ARCHITECTURAL REVIEW BOARD STAFF REPORT

Project #/Name	ARB-2024-50: Hyundai Final Site Plan
Review Type	First Review of a Final Site Plan and Third Review of Architecture
Parcel Identification	04500-00-00-068C0
Location	On the west side of Rt. 29, approximately 1280' south of the Rt. 29/Hilton Heights Rd. intersection.
Zoned	Highway Commercial (HC) / Entrance Corridor (EC) / Airport Impact Area (AIA)
Owner/Applicant	TAP Investments LLC / Design Develop LLC (Kevin Schafer)
Magisterial District	Rio
Proposal	To establish a Hyundai auto dealership consisting of one showroom with service bays; a carwash; storage, display, customer and employee parking; and associated site improvements on approximately 5.72 acres.
Context	The property is vacant and mostly wooded. The east and west perimeters of the parcel are bounded by Rt. 29 and Berkmar Drive with automotive dealerships to the north and south of the subject property. (Fig. 1.)
Visibility	The auto dealership building (Building A) and related parking and travelways adjacent to Rt. 29 will be readily visible from the EC. The carwash (Building B), located in the middle of the site, is not expected to be visible from the Entrance Corridor.

Figure 2: Proposed site plan showing the layout of buildings, travelways, vehicle storage and display areas, and parking.

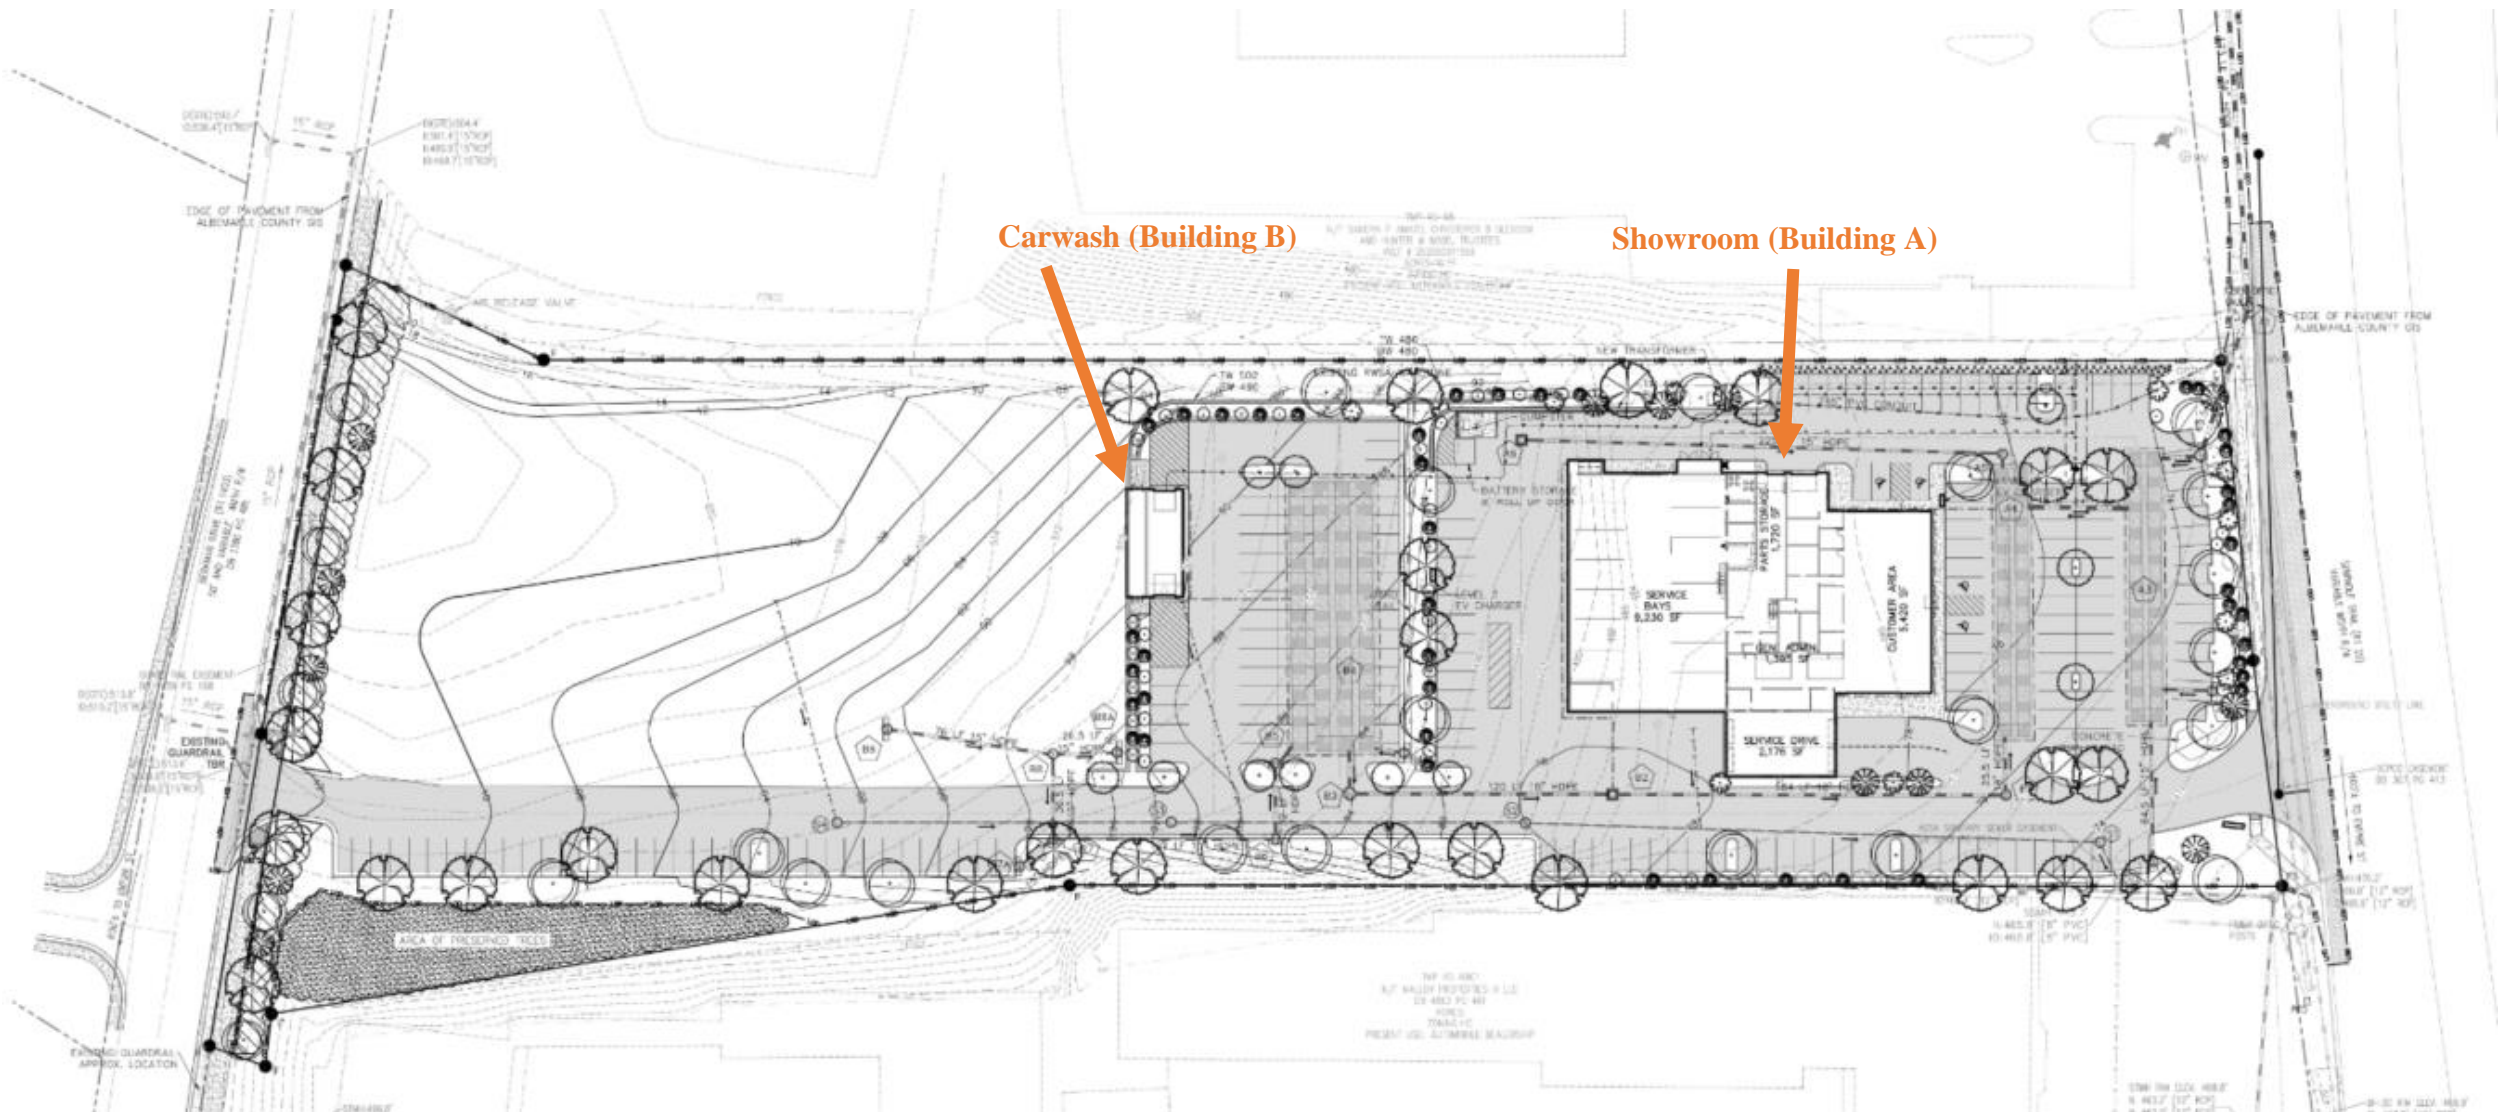
1. The architectural design of the showroom building.
2. The depth of the planting area along the southern perimeter of the site near the Rt. 29 site entrance.
3. Frontage landscape south of the site entrance along Rt. 29.
4. The concrete display pad.

12. Revise the site plan to remove two parking spaces along the southern perimeter of the site and shift the nearby trees into interior parking islands.

13. The vehicle display pad shown in the site plan is not approved. Revise the submittal documents to remove the vehicle display pad from the plan.
14. Revise the landscape plan to indicate the specific groundcover species proposed to be planted within the RWSA waterline easement. Ensure that the species chosen is included in the County's recommended species list.
